Working Party on General Safety Provisions

112th session

**Proposal for a new Regulation on uniform provisions
concerning the approval of motor vehicles with regard to the
Blind Spot Information System**

Submitted by the expert from Germany*

Figure 1: Dynamic Tests

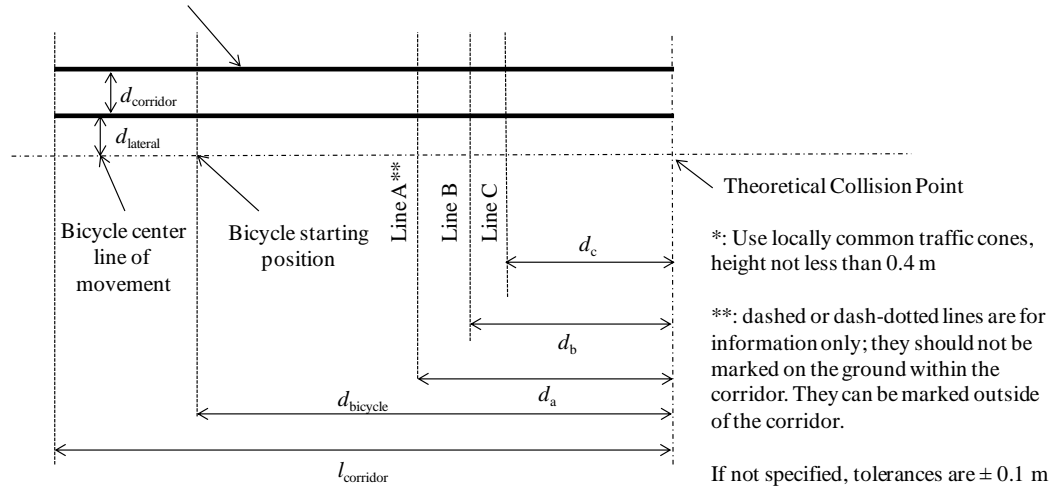
Opmerking [s11]: Paragraph reworded. All to check if it is OK now.

Opmerking [w12]: To be discussed based on general GSR approach. Options see comment to 5.3.1.3. (required speeds). Proposal: P/F criteria is LPI at 15 m line for all cases.

Figure 2: Static Tests

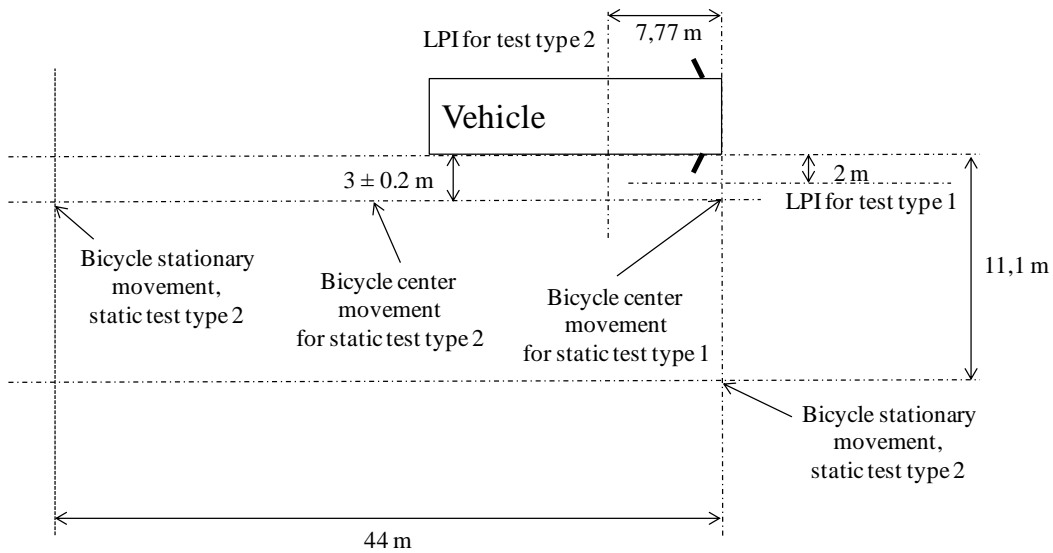
Opmerking [s14]: Background: This test is meant to replicate roundabout situations

Opmerking [s15]: 1.4 s TTC

Opmerking [s16]: No further definition of planes is needed to my understanding: 2 m away refers to the position the bicycle would impact the vehicle on its line of movement.

Opmerking [s17]: Background: This test is meant to replicate situations with a stopped truck due to traffic and fast approaching (additional) bicycles from the rear.

Opmerking [s18]: 8 s TTC

Opmerking [s19]: 1.4s TTC for 20 km/h

Figure 2
Bike target dimensions and dummy posture

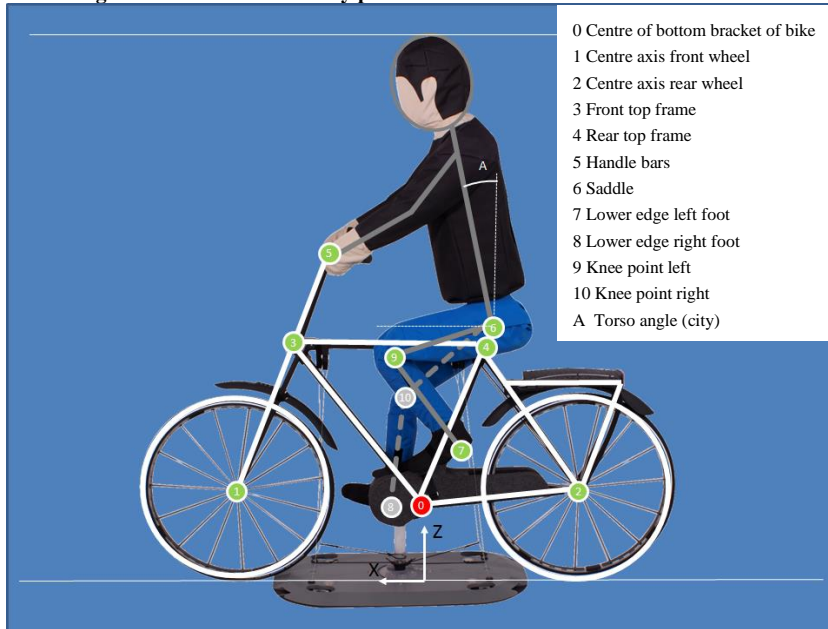
Opmerking [HF26]: Is it possible to be less design restrictive for bicycle target keeping a defined detectability level regarding detection technology used ?

Opmerking [s28]: Discuss about type of bicycle; whether this bike is appropriate.

Opmerking [HF31]: Need to open technology to ultra sonic systems too.

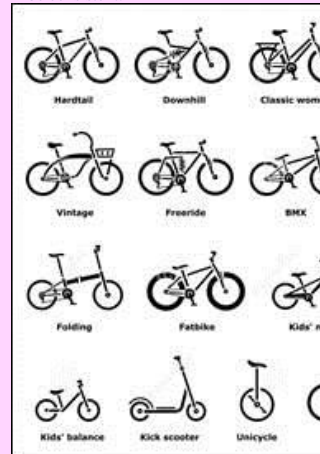
Opmerking [s33]: -§ 2.3. on “bicycle” definition : based on the bicycle-type picture below, a short study brings a saddle + manikin torso height in line with the dimensions in annex 3 for the bicycle target (935+877.cos(10)=1799). Unless there are new discussions on this topic during the 30th meeting, it seems to be consistent.
